RECALL CAMPAIGN BULLETIN

NTB16-054a August 16, 2016

VOLUNTARY SAFETY RECALL CAMPAIGN OCCUPANT CLASSIFICATION SYSTEM CONTROL UNIT REPLACEMENT

Front Passenger Air Bag Status Light

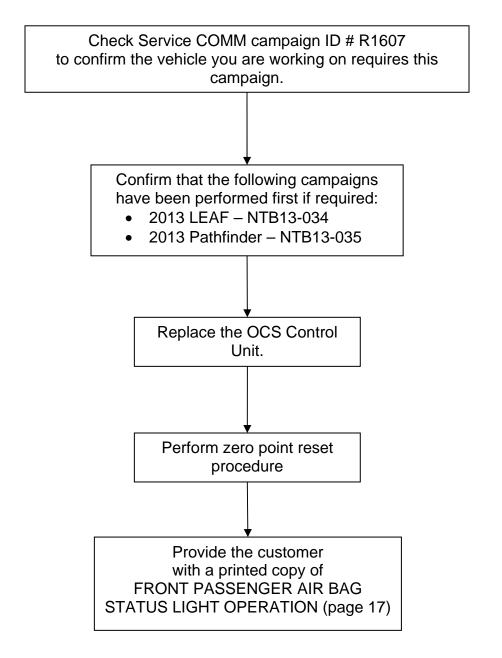
Performing the procedures in this bulletin (campaign R1607) changes the operation of the passenger air bag status light.

After performing this campaign, the passenger air bag status light will be ON (illuminated) when the front passenger seat is empty.
